LAGUNA II ESPACE ESPACE IV VEL SATIS AVANTIME

fitted with G9T 702 - 710 - 712 - 742 engine

TDC SENSOR

OTS: 0A99

Fig. 1

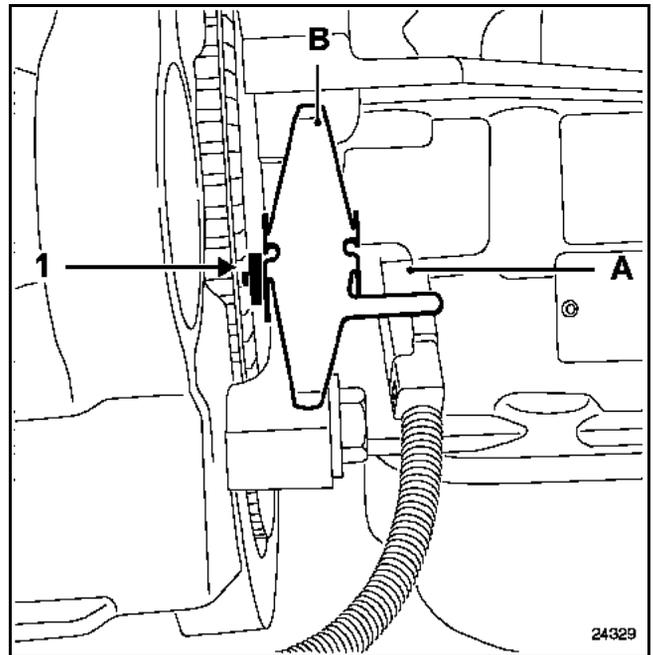
- Remove the engine undertray.
- Replace the TDC sensor (A) and its mounting clip (B) (Fig. 1).

IMPORTANT: the TDC sensor should slide freely in the clip when it is fitted.

- The TDC sensor **MUST** butt up to the flywheel (1) (Fig. 1).

Fig. 2

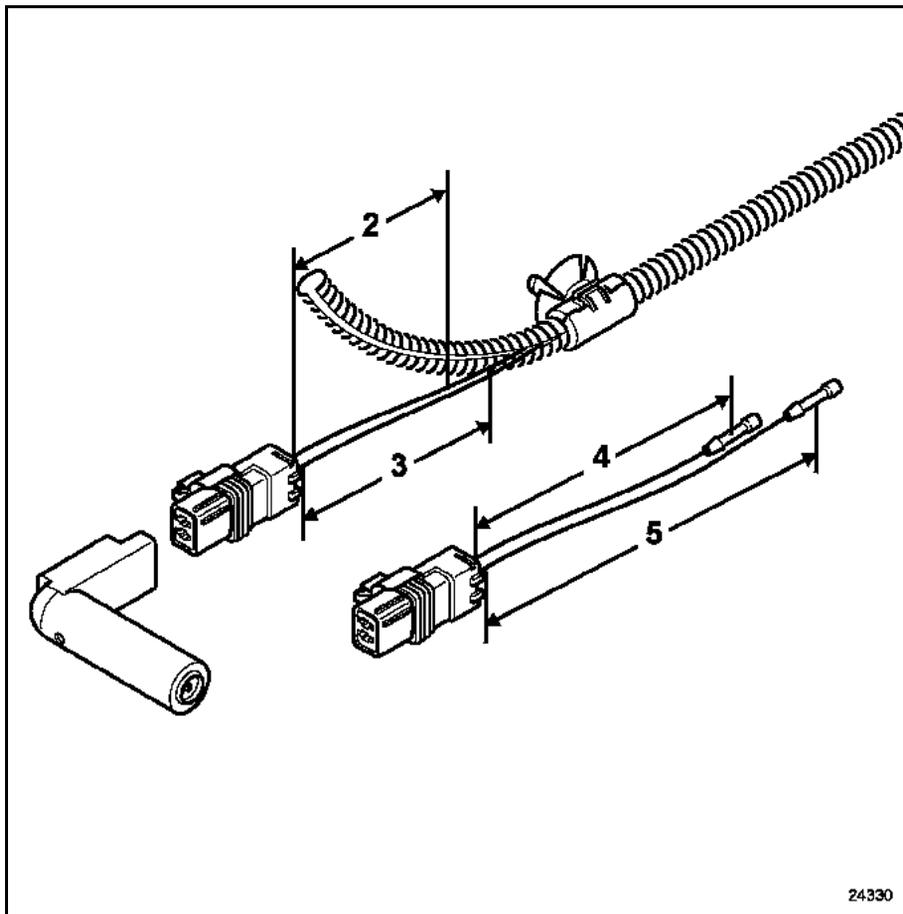
- Replace the TDC sensor connector on the engine harness:
 - Remove the annealed sheath from the TDC connector wiring harness.
 - Cut the wire of track no. 1 at **120 mm (2) (Fig. 2)** from the rear of the TDC sensor connector.
 - Cut the wire of track no. 2 at **160 mm (3) (Fig. 2)** from the rear of the TDC sensor connector.

IMPORTANT: track allocations MUST be adhered to.

- Reconnect the sleeves of the new connector to the engine harness with a crimping tool.

- 2 – length of track no. 1 wire on old connector: 120 mm
- 3 – length of track no. 2 wire on the old connector: 160 mm
- 4 – length of track no. 1 wire on new connector: 140 mm
- 5 – length of track no. 2 wire on new connector: 180 mm
